# Standard Form of Agreement Between Owner and Contractor where the basis of payment is a Stipulated Sum

Hunt Street Park Central Falls 406 Hunt Street Central Falls, RI 02863

## HUNT STREET PARK PROPOSED PROJECT SCOPE REVISIONS

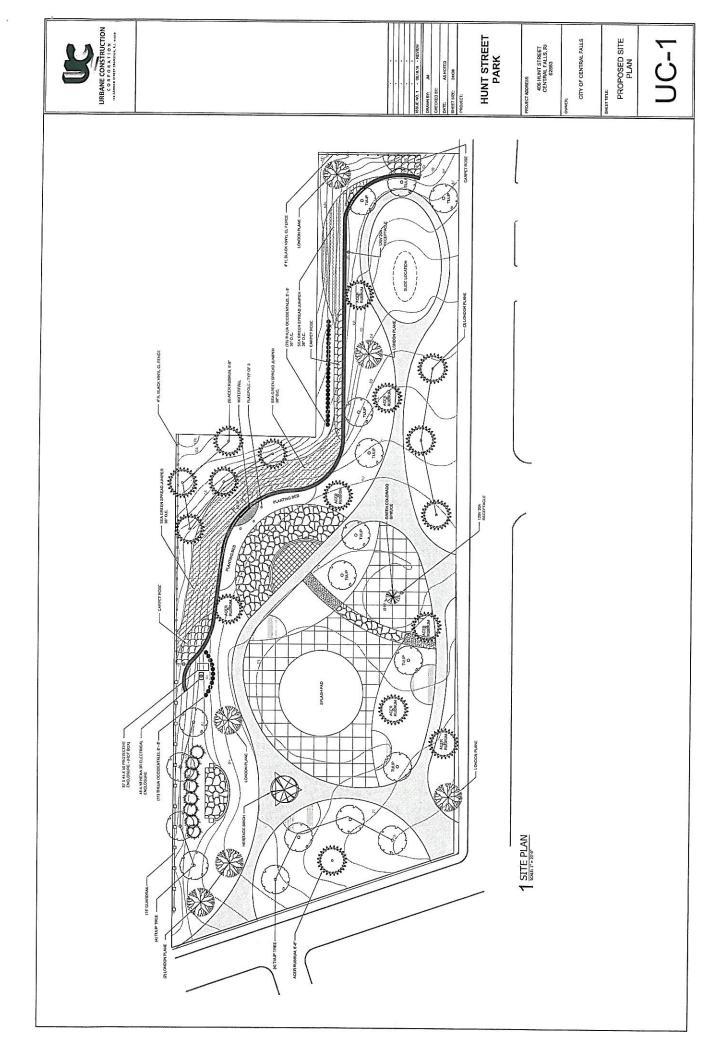
Delete all versa-lok walls (substitute Redi-Rock wall as shown on UC-1 dated 8.18.16)

Include a 10 linear foot waterfall integrated into the Redi-Rock wall as shown on UC-1 dated 8.18.16.

Modify planting layout shown on L.01 to that shown on UC-1 dated 8.18.16.

Delete Pump House and all associated work (substitute Hot Box as shown on UC-1 dated 8.18.16)

Delete all 120V receptacles shown on drawings. (Substitute with 2 as shown on UC-1 dated 8.18.16)
